ECE/TRANS/WP.29/GRE/2009/60  
14 July 2009

REGULATION No. 37  
(Filament lamps)

Proposal for Supplement 35 to the 03 series of amendments to Regulation No. 37

**Sheet W10W/1**

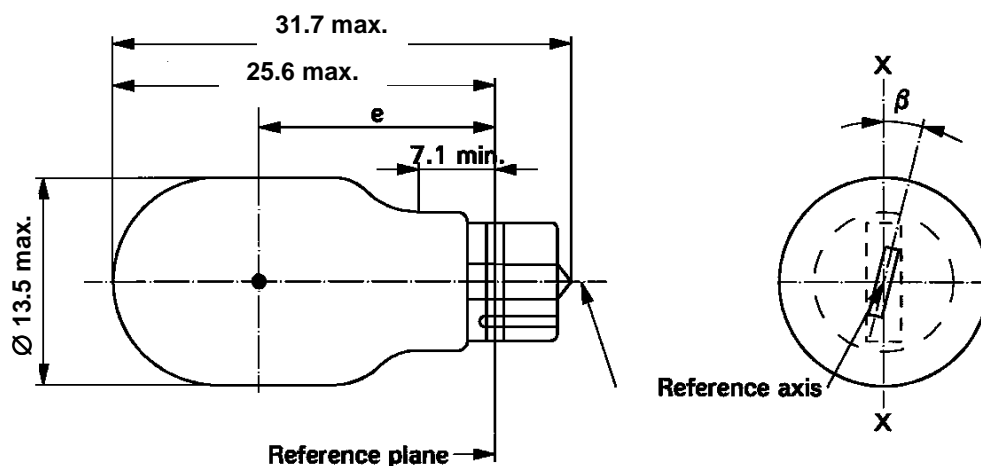
Insert a new sheet W10W/1, between sheet W5W/1 and sheet W15/5W/1, to read:  
(see next pages).

Dimensions in mm		Filament lamps of normal production			Standard filament lamp
		min.	nom.	max.	
e		15.5	17.0	18.5	17.0 ± 0.3
Lateral deviation	<u>1/</u>			1.0	0.5 max.
$\beta$		-15°	0°	+ 15°	0° ± 5°
Cap W2.1x9.5d in accordance with IEC Publication 60061 (sheet 7004-91-3)					
<b>ELECTRICAL AND PHOTOMETRIC CHARACTERISTICS</b>					
Rated values	Volts	6		12	12
	Watts	10			10
Test voltage	Volts	6.75	13.5		13.5
Objective values	Watts	11 max.			11 max.
	Luminous flux	White	125 ± 20 %		
		Amber	75 ± 20 %		
Reference luminous flux at approximately 13.5 V:					White: 125 lm
					Amber: 75 lm

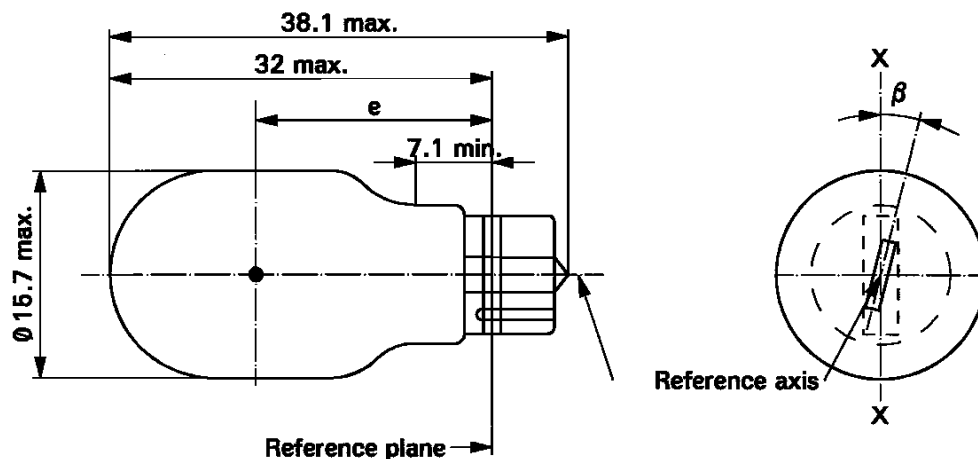
Replace sheet W16W /1, by a new sheet, to read: (see next pages).

Dimensions in mm		Filament lamps of normal production			Standard filament lamp
		min.	nom.	max.	
e		18.3	20.6	22.9	20.6 ± 0.3
Lateral deviation <sup>1/</sup>				1.0	0.5 max.
β		-15°	0°	+ 15°	0° ± 5°
Cap W2.1x9.5d in accordance with IEC Publication 60061 (sheet 7004-91-3)					
ELECTRICAL AND PHOTOMETRIC CHARACTERISTICS					
Rated values	Volts		12		12
	Watts		16		16
Test voltage	Volts		13.5		13.5
Objective values	Watts		21.35 max.		21.35 max.
	Luminous flux	White	310 ± 20 %		
		Amber	190 ± 20 %		
Reference luminous flux at approximately 13.5 V:					White: 310 lm
					Amber: 190 lm
